APPROVAL DATE: 8/18/17 **PERMIT: CONSTRUCTION** A 560629-F

PROPERTY ADDRESS: 5620 CHAMBLIS DRIVE, CLARKSVILLE, MD 21029 (TENANT HOUSE AT 5610 CHAMBLIS DRIVE)

RE: Glen Mary Estates / Lot 6 / Tenant House
B16002797

ONSITE SEWAGE DISPOSAL SYSTEM DESIGN PLAN
GLEN MARY ESTATES
 LOT 6
 TENANT HOUSE
 (B 16002797)
 TAX MAP 34 GRID 5 PARCEL 15
 TAX ACCOUNT #05-341140
 5TH ELECTION DISTRICT HOWARD COUNTY, MD
 DATE: 3/2017 SCALE: AS SHOWN
 SHEET 1 OF 2

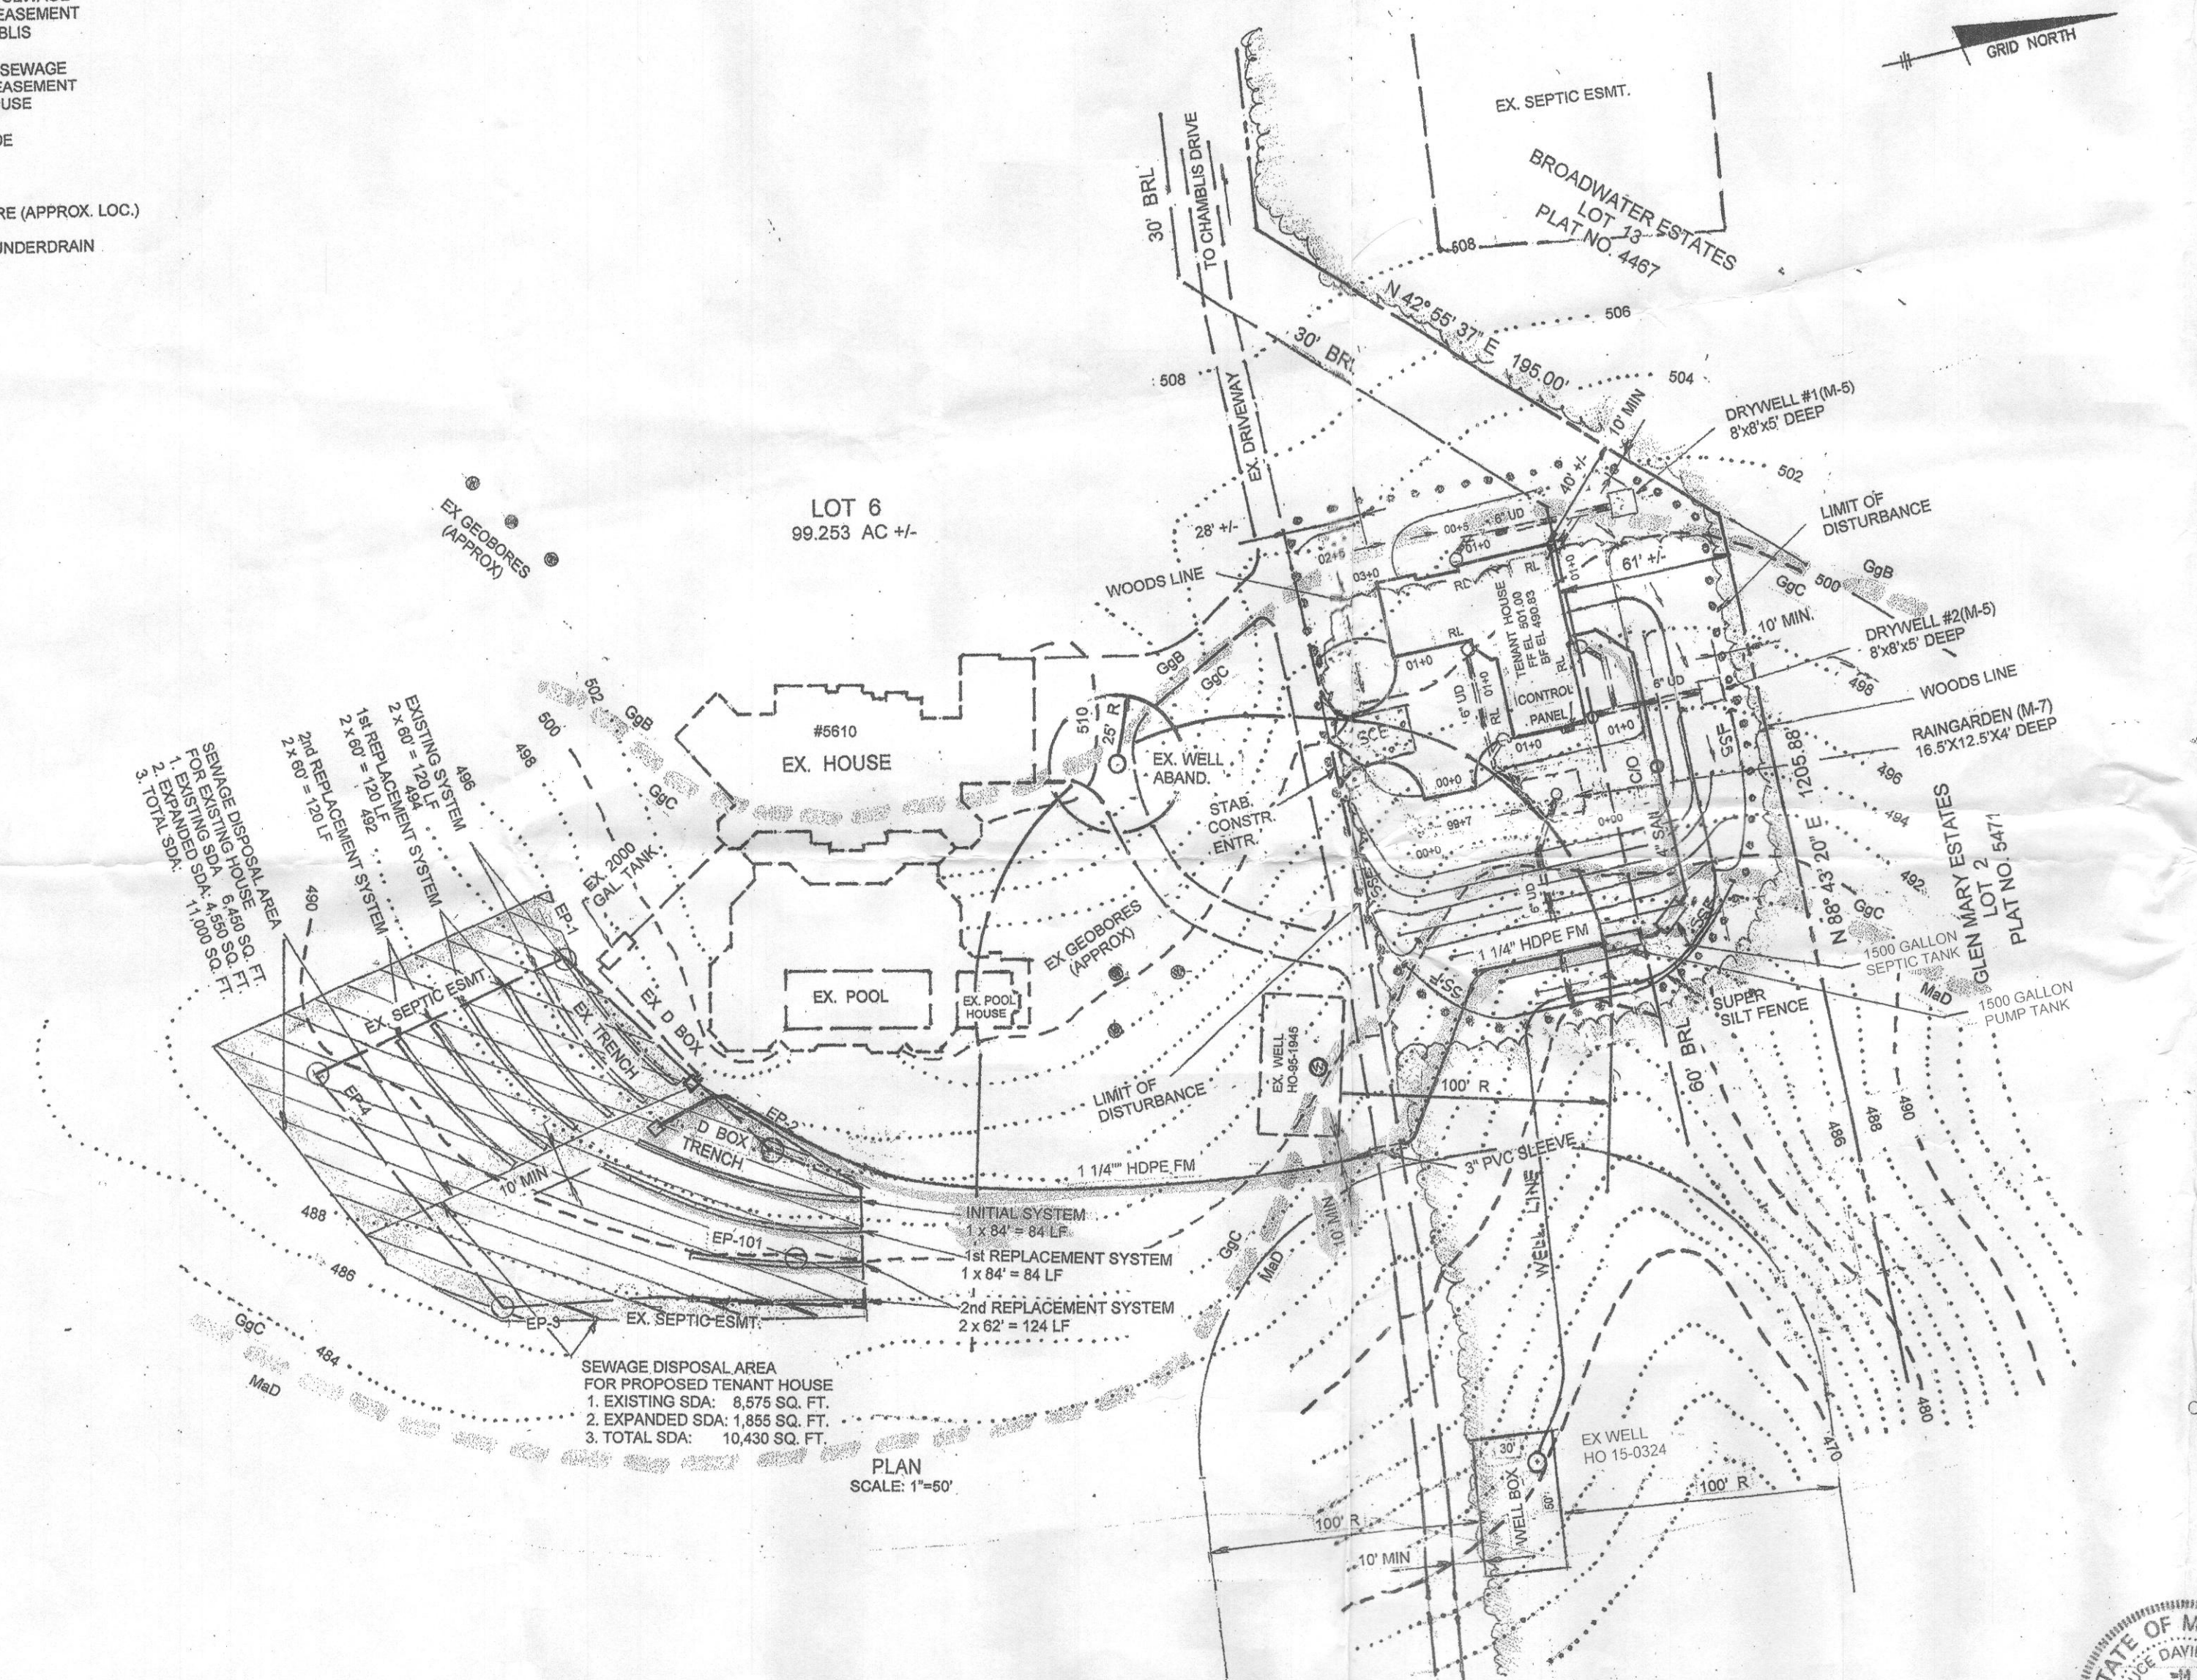
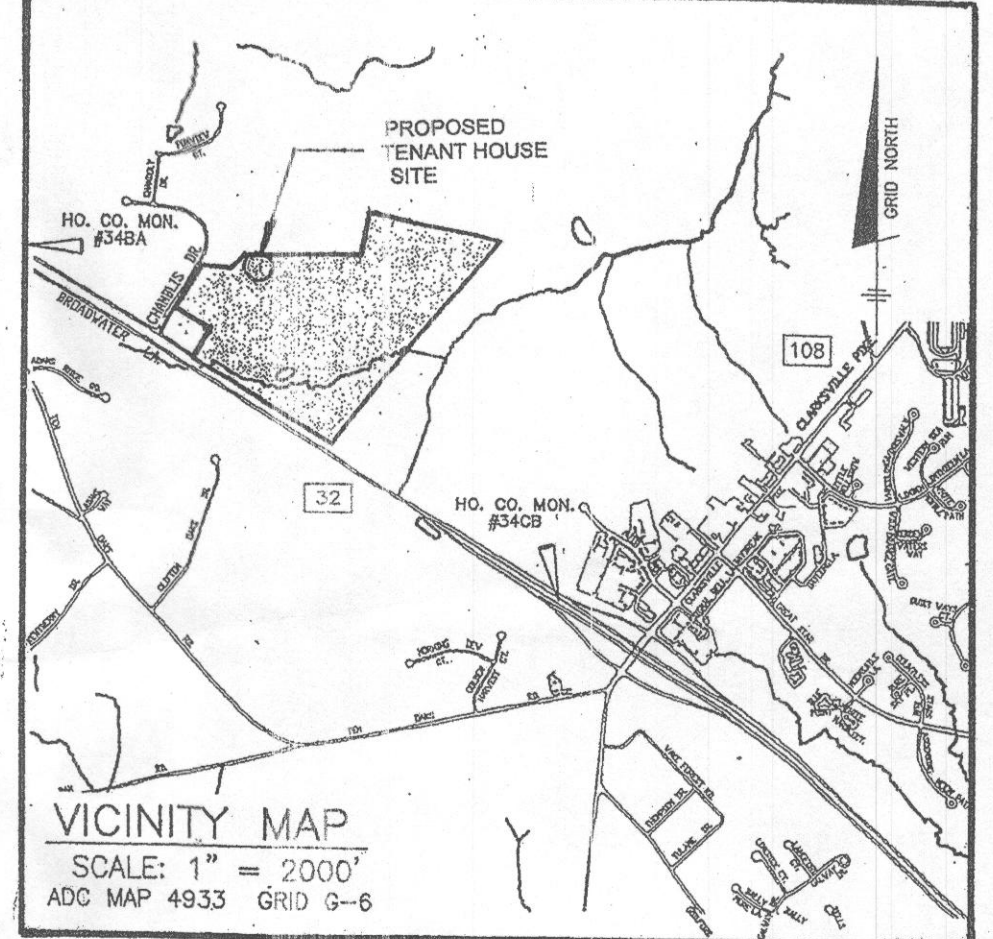
PURPOSE NOTE
 THE PURPOSE OF THIS PLAN REVISES THE PREVIOUSLY APPROVED "BAT SITE PLAN" DATED 11/01/2016 TO A CONVENTIONAL "ONSITE SEWAGE DISPOSAL SYSTEM DESIGN PLAN".

NO	DATE	REVISION
1	3/27/17	REVISE FROM BAT SYSTEM TO CONVENTIONAL

ONSITE SEWAGE DISPOSAL SYSTEM DESIGN PLAN
GLEN MARY ESTATES
LOT 6
TENANT HOUSE
(B 16002797)
TAX MAP 34 GRID 5 PARCEL 15
TAX ACCOUNT #05-341140
5TH ELECTION DISTRICT HOWARD COUNTY, MD
DATE: 3/2017 SCALE: AS SHOWN
SHEET 2 OF 2

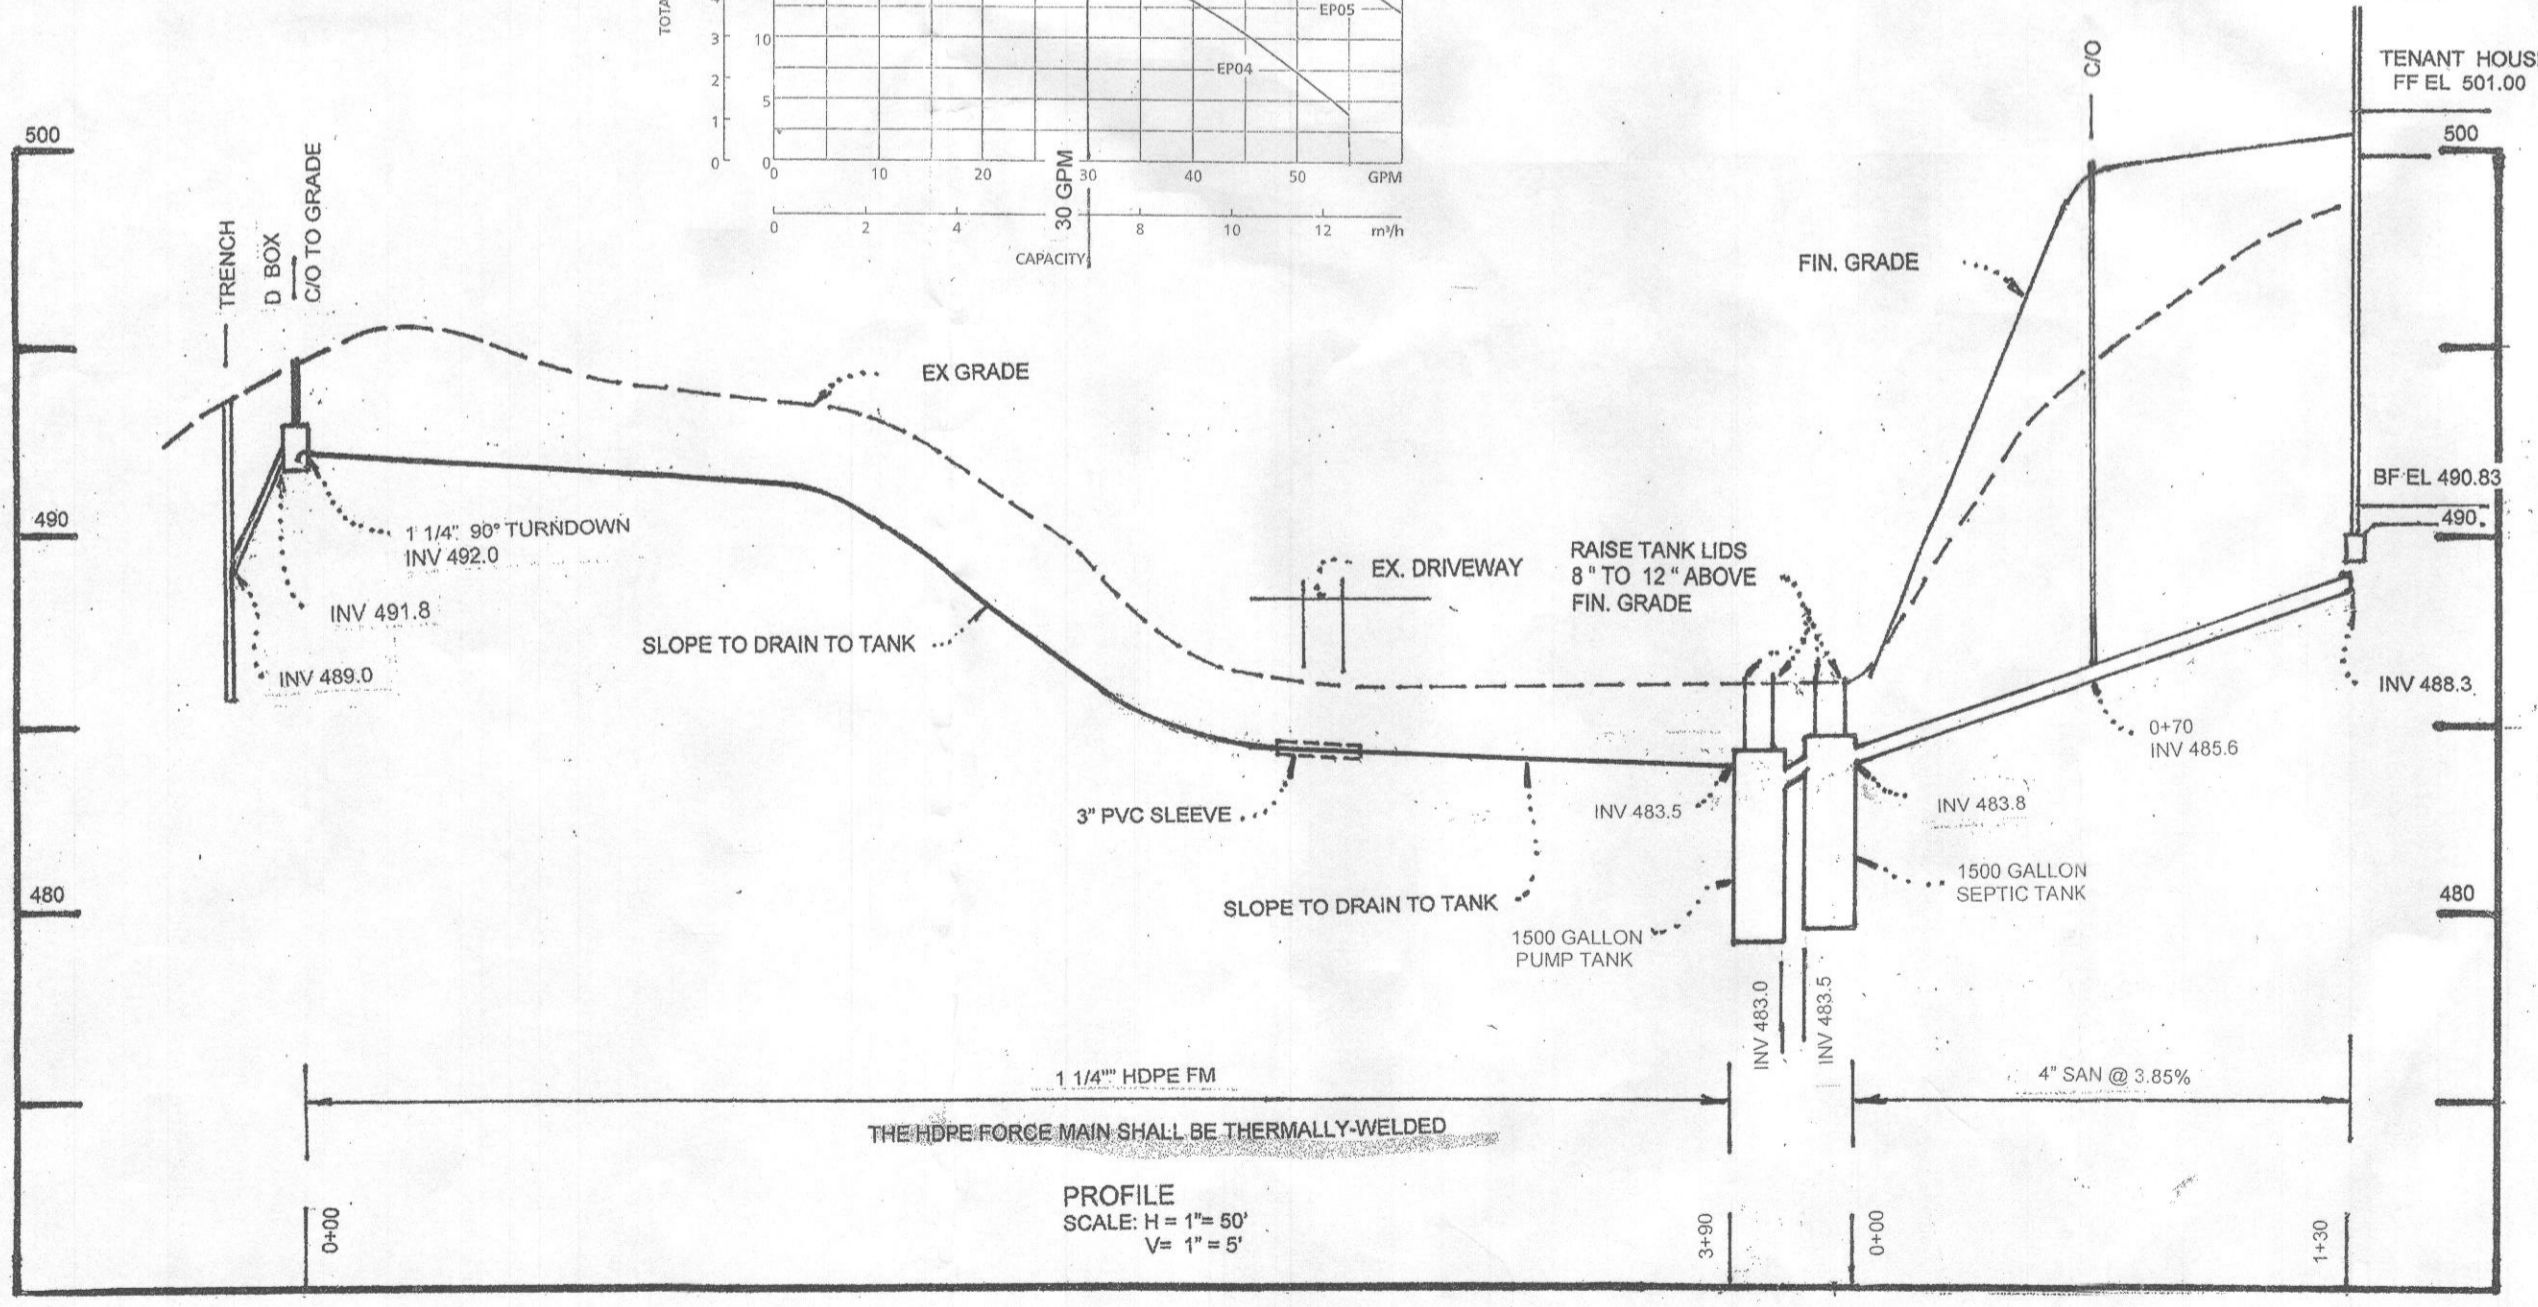
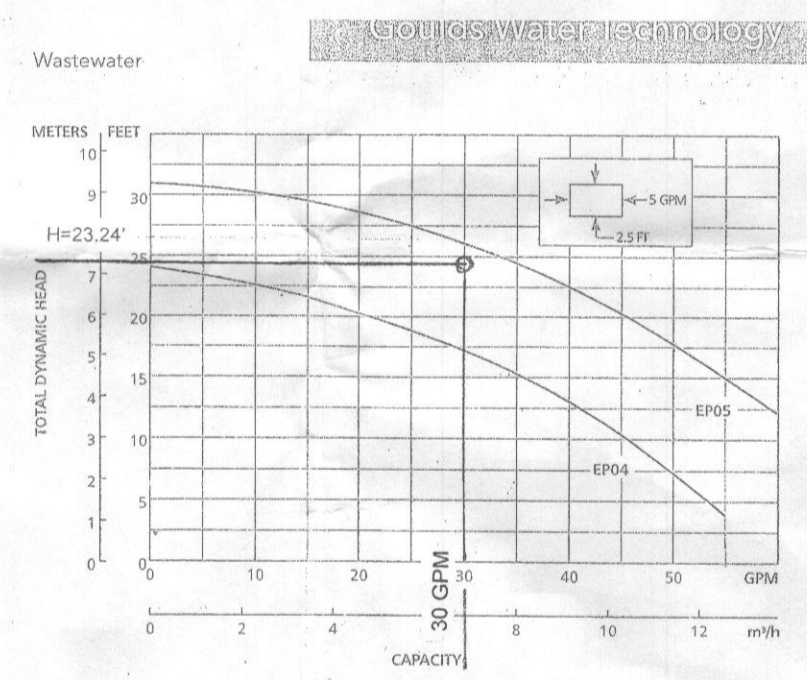
PURPOSE NOTE
THE PURPOSE OF THIS PLAN REVISES THE PREVIOUSLY APPROVED "BAT SITE PLAN" DATED 11/01/2016 TO A CONVENTIONAL "ONSITE SEWAGE DISPOSAL SYSTEM DESIGN PLAN".

NO	DATE	REVISION
1	3/22/17	REVISE FROM BAT SYSTEM TO CONVENTIONAL
